Project No. 07524-32-02
February 19, 2019

Subject: ADDENDUM TO GEOTECHNICAL REPORTS
STONE CREEK
VESTING TENTATIVE MAP NO. 208328; PTS NO. 67943; W.O. NO. 42-2637
SAN DIEGO, CALIFORNIA

Subject: SLOPE STABILITY ANALYSIS FOR RECLAMATION SLOPES
CARROLL CANYON MINE
SAN DIEGO, CALIFORNIA

Carroll Canyon Mine
Project No. 07524-32-02
File Name: 2-to-1 Slope Fill Slope.gsz
Date: 05/28/2020

Figure 1

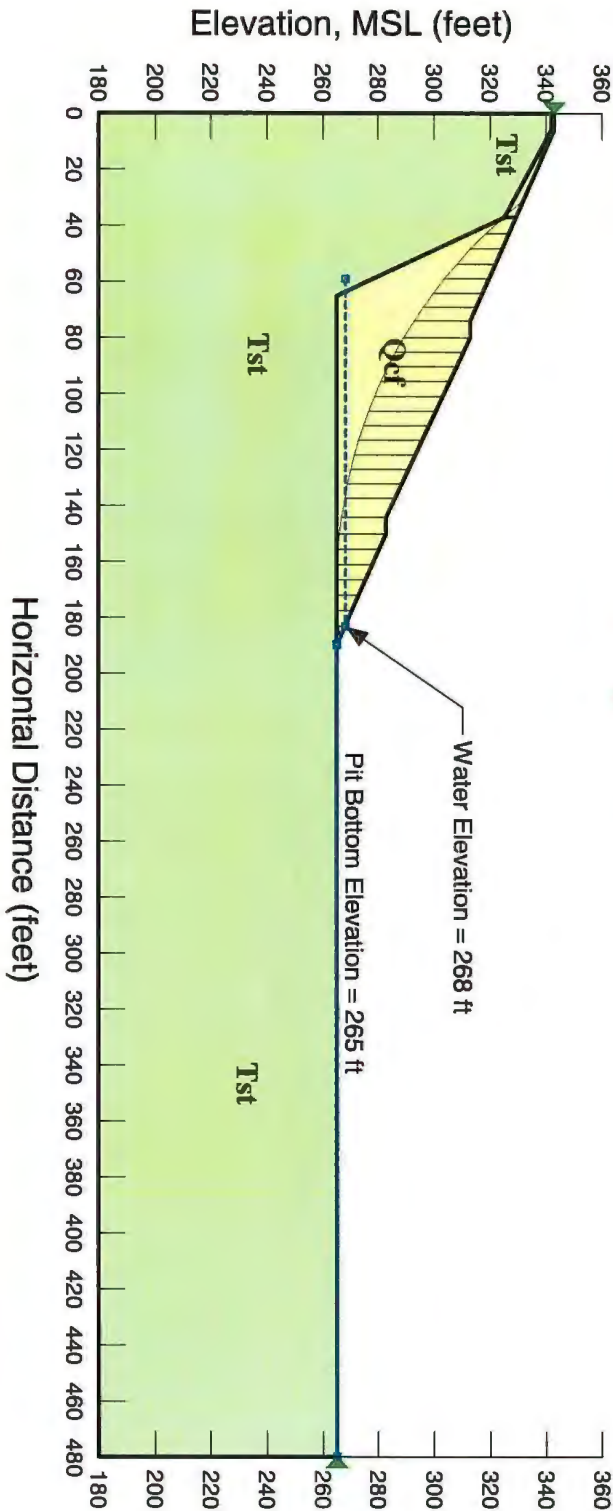
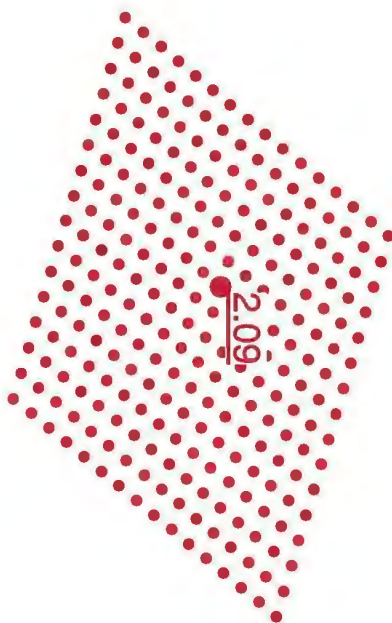
Comment:

MSL). The bottom of the basin is at 265 feet MSL. The results of our analyses indicate the basin slopes are stable with a factor of safety in excess of 1.5. Figure 1, attached, graphically depicts the stability analyses. The shear strength parameters used in the analysis are based on our experience with the Stadium Conglomerate and compacted fill generated from Stadium Conglomerate excavations.
